**SYDNEY METRO CITY & SOUTH WEST
 CONSTRUCTION TRAFFIC MANAGEMENT PLAN
 CHATSWOOD DIVE SITE**

MAY 2017

CTMP Review Comments Sheet

DRAWING No:	DD-SYDM-DWG-0001-02	
SHEET	1	OF 1
REVISION	E-00

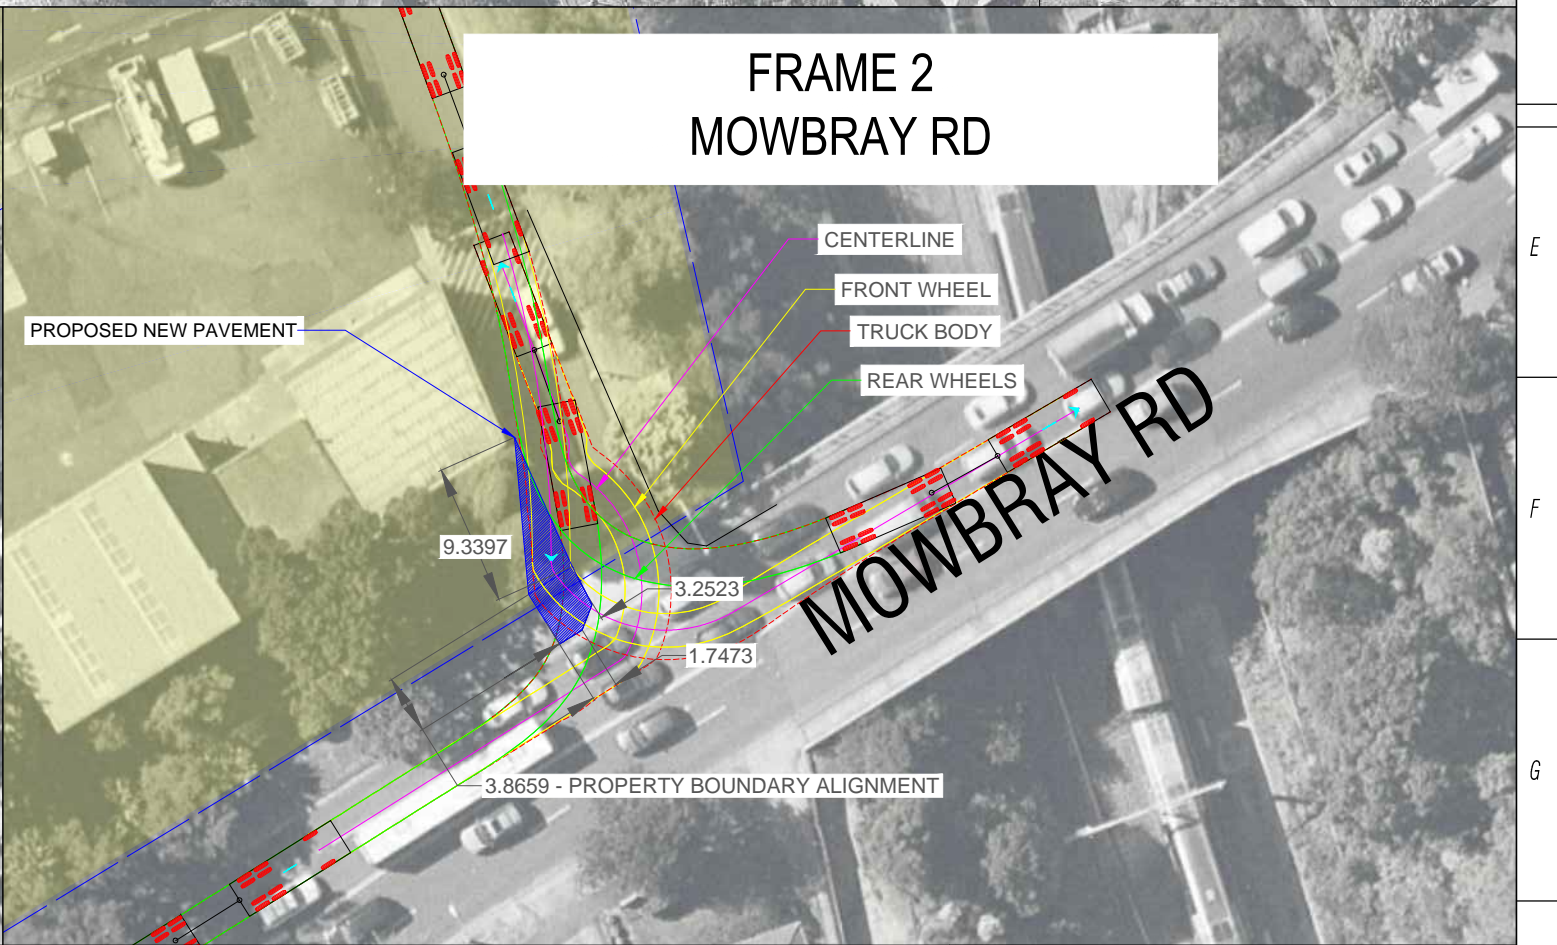
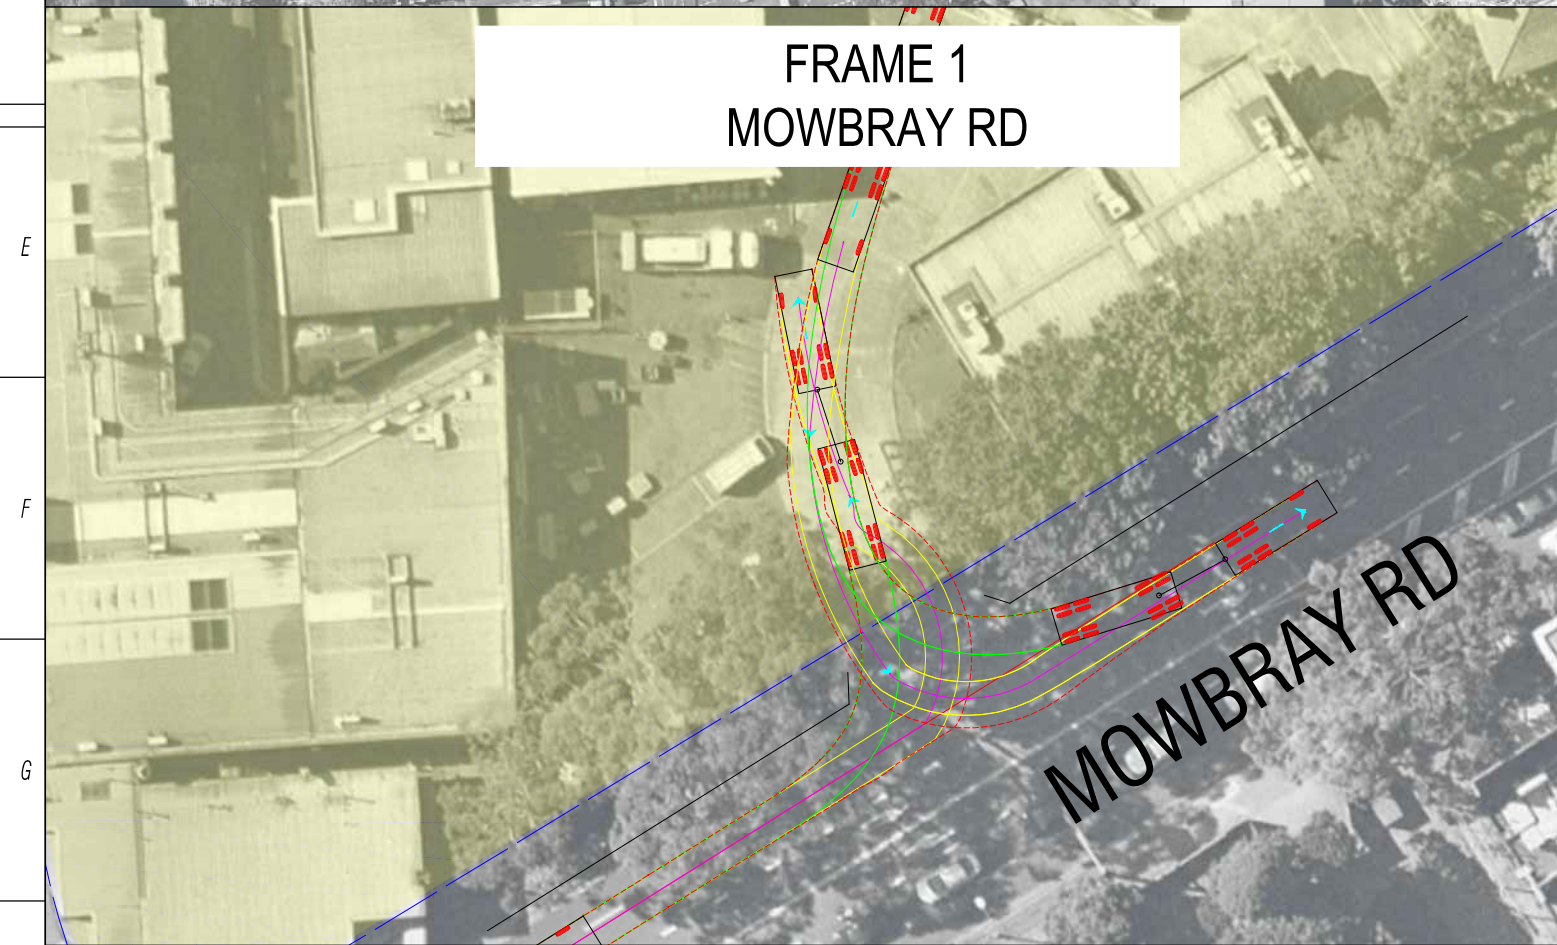
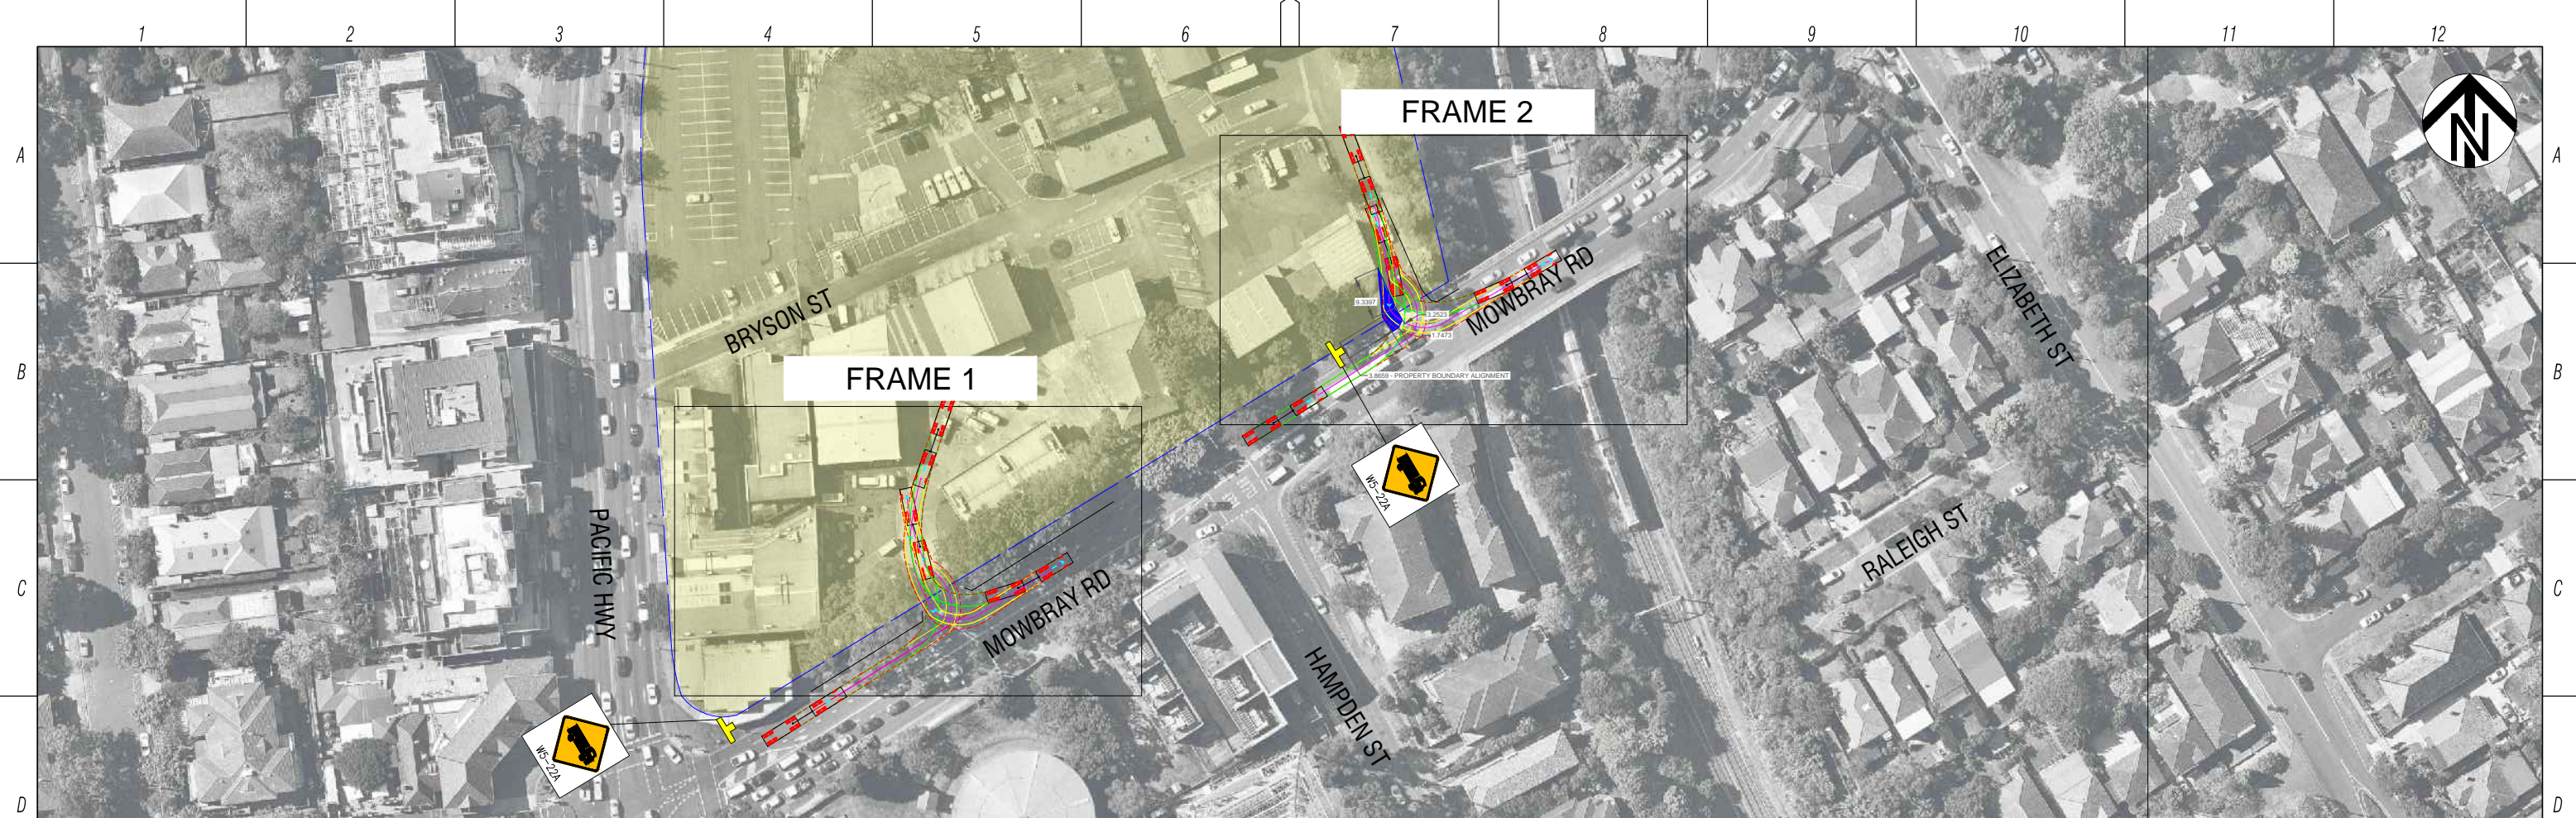
11	Appendix 1	Mowbray’ is misspelt, Hampden Road is labelled as Elizabeth St	Document amended
12	Appendix 2	Proposed Access/Egress – ‘Mowbray’ misspelt in Frame titles	Document amended
13	Appendix 3	TCP Sheet 2 – Departing speed limit on Mowbray Road East should be ‘50km/h’, not 60 as shown	Document amended
14	Appendix 3	TCP Sheet 2 – The northbound approach and management of the dual lane right turn bay on Pacific Highway appears confusing. The right lane is closed off on the approach but then vehicles are directed into the right lane at the stop line. Is that correct?	This is typically how these are closed as it provides greater safety for the traffic controller during set up/ demobilising and for maintenance during the lane closure

<p>Appendix 2 Frame 1 – egress on Nelson Street shows removal of parking spaces due to swept path of vehicles including travel over K&G and footpath and through a street tree. Has this been approved?</p>	<p>As Council would be aware, this CTMP has not been approved, hence neither has the use of this driveway. We have now reviewed the access and will limit access to Mowbray Road. Drawing amended</p>
		<p>Appendix 2 Frame 2 shows that large vehicle cannot turn into driveway without entering second lane. Picture shows vehicle mounting K&G and footway</p>	<p>Drawings have been amended to show the swept paths and the amount of works to modify the current vehicle crossings</p>
		<p>Appendix 2 Frame 3 trailers will not be able to access site without access to second lane without mounting K&G and footway</p>	<p>Driveway will be altered to suit turning movements. Drawing amended</p>

Drawing 0001-02 text is Nelson Street but is actually Mowbray Road - Drawing amended
